A D D E N D U M

Project No.: 2401519
Project: YWCA of NE IN Hefner Kitchen

Addendum No: 3
Date: 12/02/2024

ADDENDUM NO. 3, to Drawings and Specifications dated 10/30/2024, for the Hefner Kitchen project for the YWCA of Northeast Indiana; as prepared by ELEVATUS Architecture, 111 E. Wayne Street, Suite 555, Fort Wayne, IN 46802

Item #1: Drawing Sheet E2.01

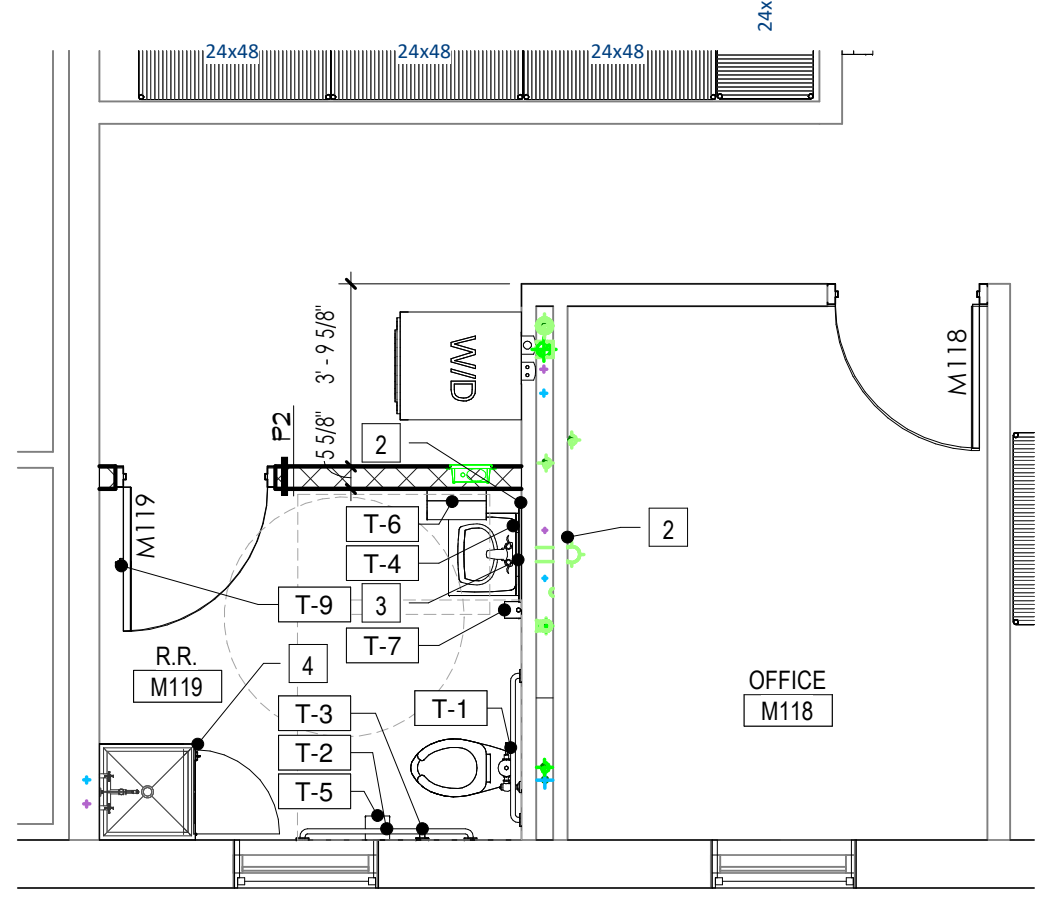
- A.** All receptacles in Kitchen M104, Kitchen M117, Training Kitchen M121 and Warming Kitchen M122 shall be GFCI protected devices (non feed-through).
- B.** All exposed conduit in Kitchen M104, Kitchen M117, Training Kitchen M121 and Warming Kitchen M122 shall be ERMC (threaded rigid) type with FS type boxes up to above ceiling. Rooms are to be considered WET location below ceiling.
- C.** Panelboards K1, K2 & K3 shall be flush type covers in furred-out wall construction.

A2.11

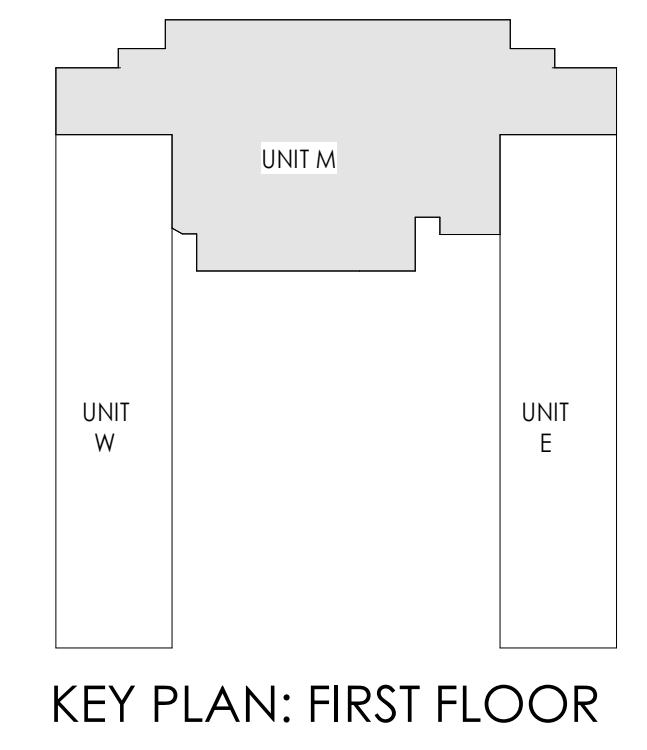
ITEM NO. 2.01 - DRAWING NO. – A2.11 FIRST FLOOR PLAN – UNIT M

- A. Walls to be furred out at locations where panelboards K1, K2, and K3 exist.

- FIELD VERIFY EXACT LOCATION OF FURRED OUT WALL WITH PANELBOARD INSTALL LOCATION
